GS-13 Interface

Title GS-13 Interface Card		Ligo Project California Institute of Technology Massachusetts Institute of Technology		
Size: C	DCC Number: D070115-00-C			
Drawn by: Ben Abbott	Date: 5/8/2009	Revision: B3		
File: C:\Ben\Seismic\ISL\LASTI_ISI\ISI Interface\GS13Interface\GS13Interface.dwg 11/12/2009 18:30 PM Sheet 1 of 2

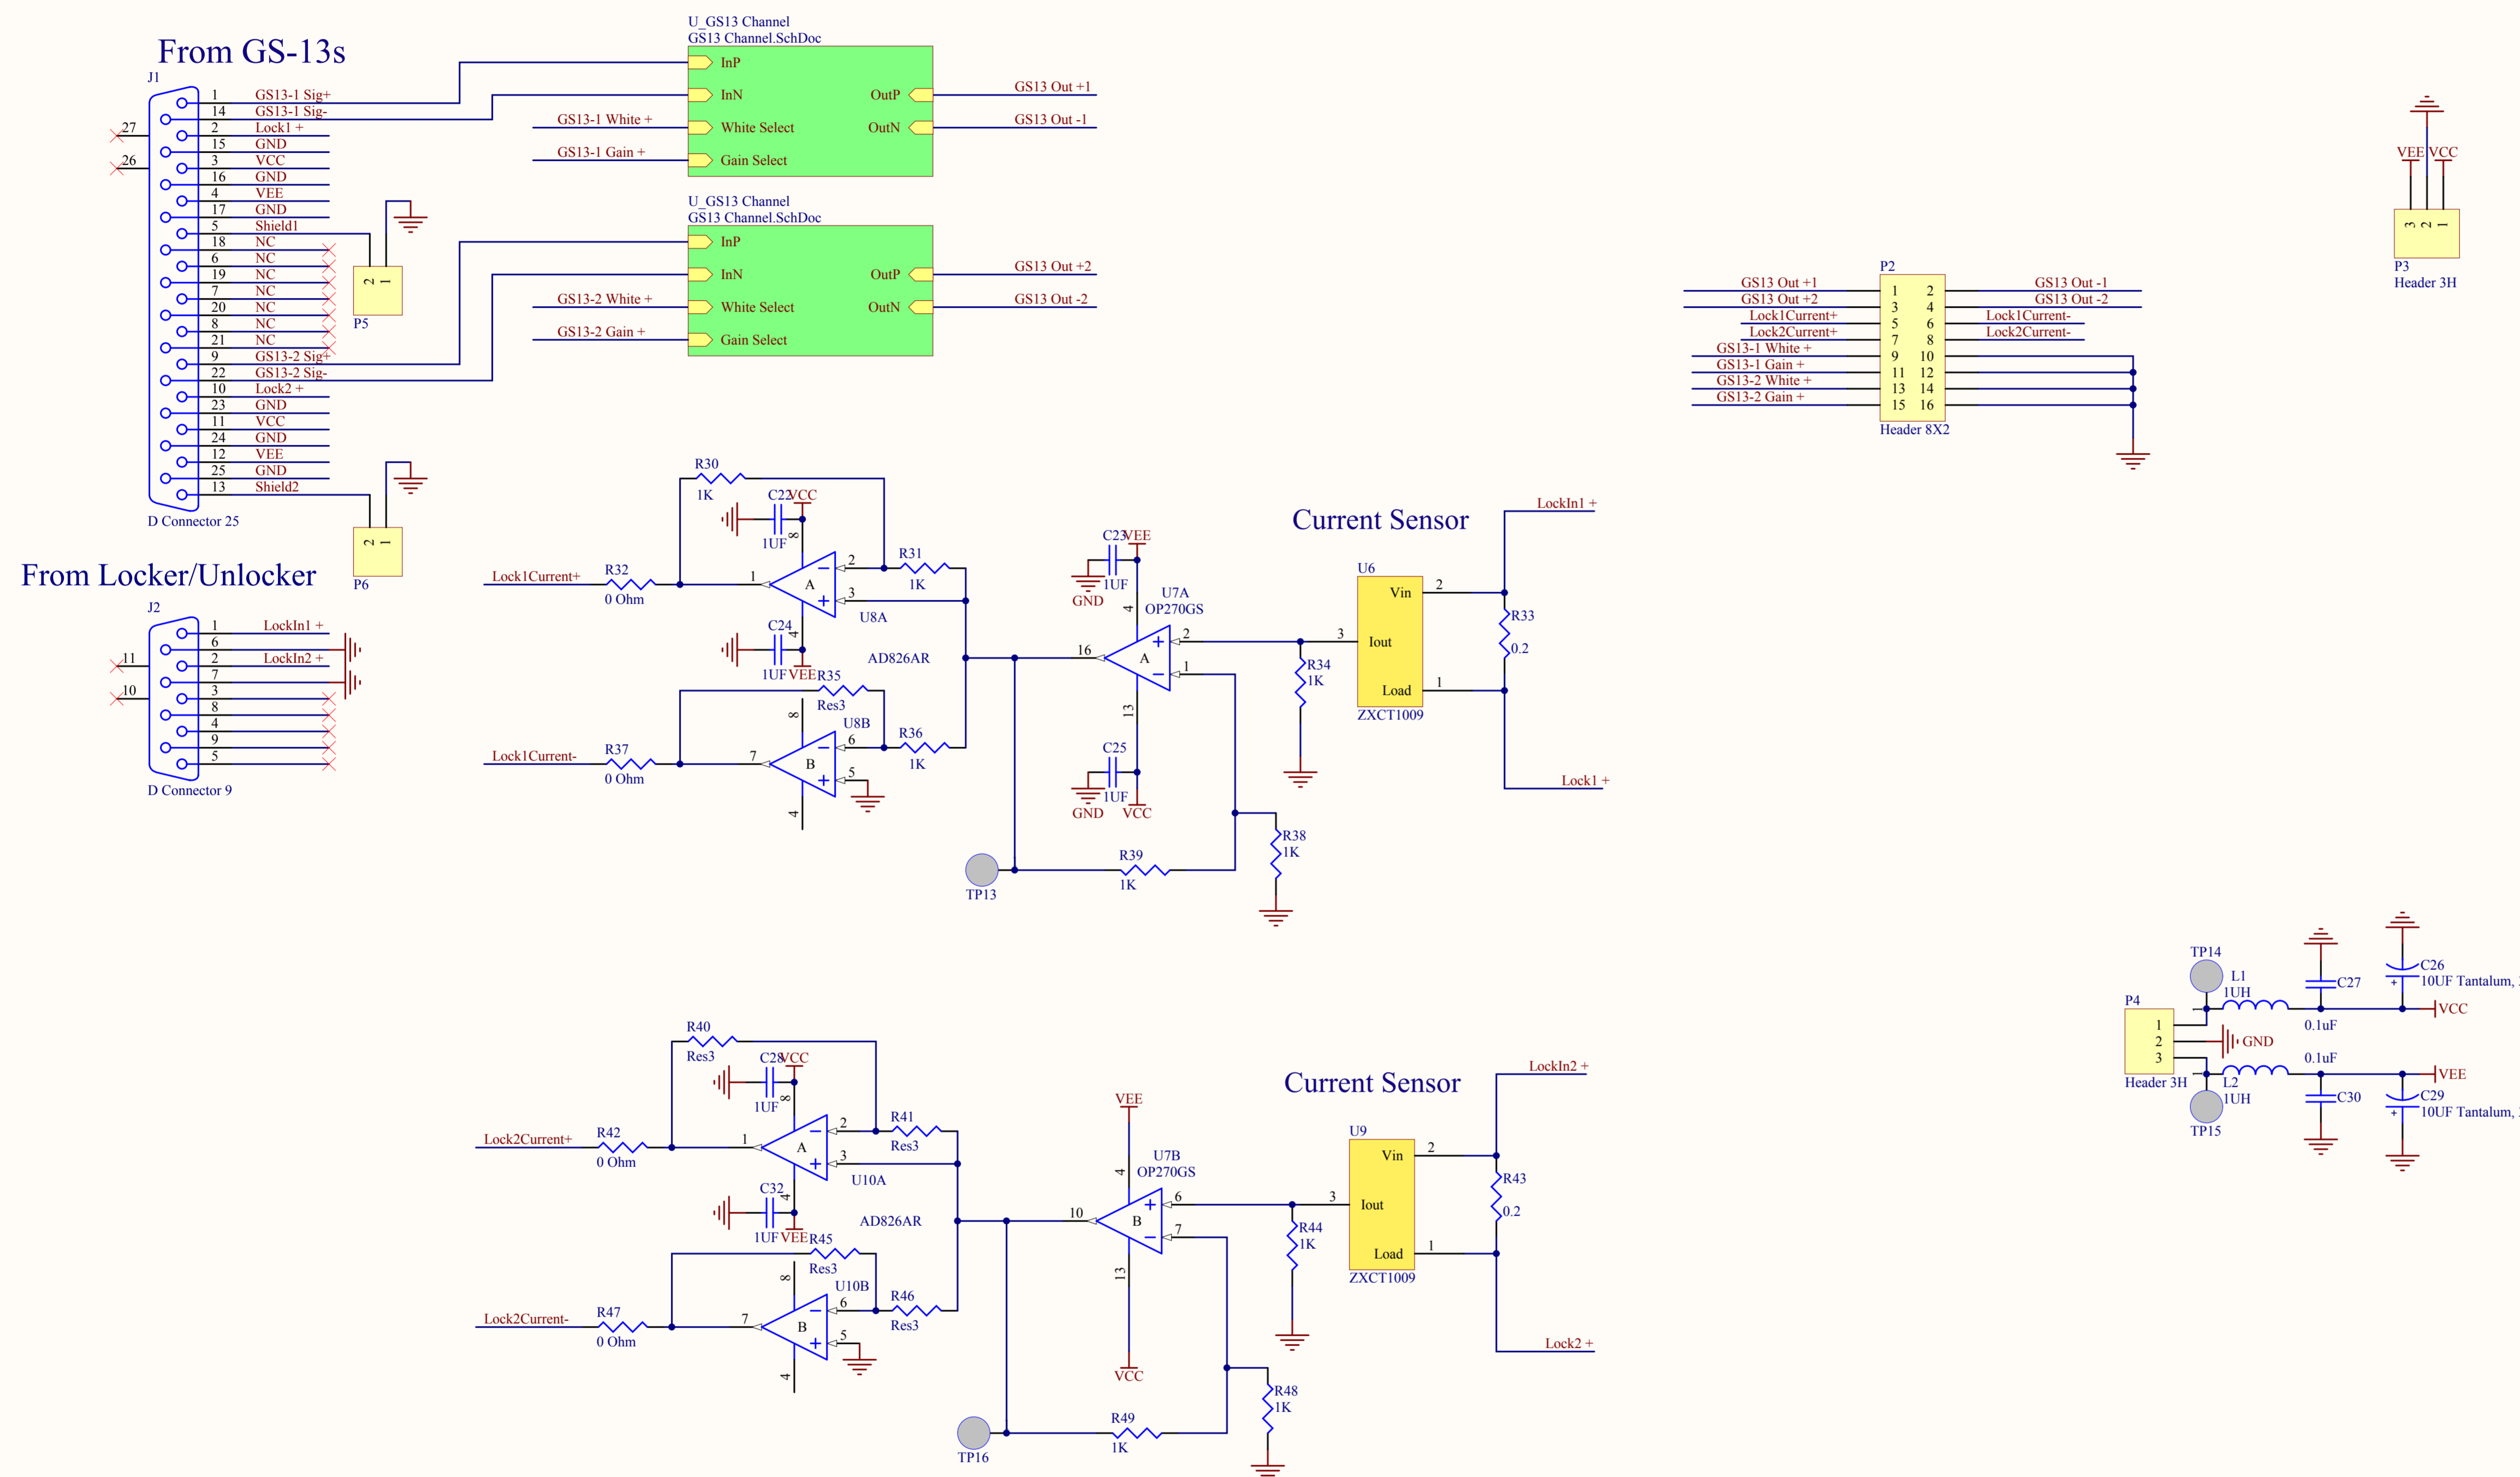
Changes from Rev B1 to B2 are written in red below, and involve C1, C2, C11, C12, C15, and C16

Also, R13, R14, R15 & R16 are changed

Rev. B3 changes C10 from 820pF to 16nF

C1 Changed from .002uF to 550pF

C2 Changed from .002uF to 550pF

C11 & C12 Changed from .01uF to .0047uF

R4 and R29 changed to 2K from 1K to use full range of the ADC input.

C15 & C16 Changed from .022uF to .01uF
R13, R14, R15 & R16 Changed from 16.2K to 8.06K

C10 changed from 820pF to 16nF
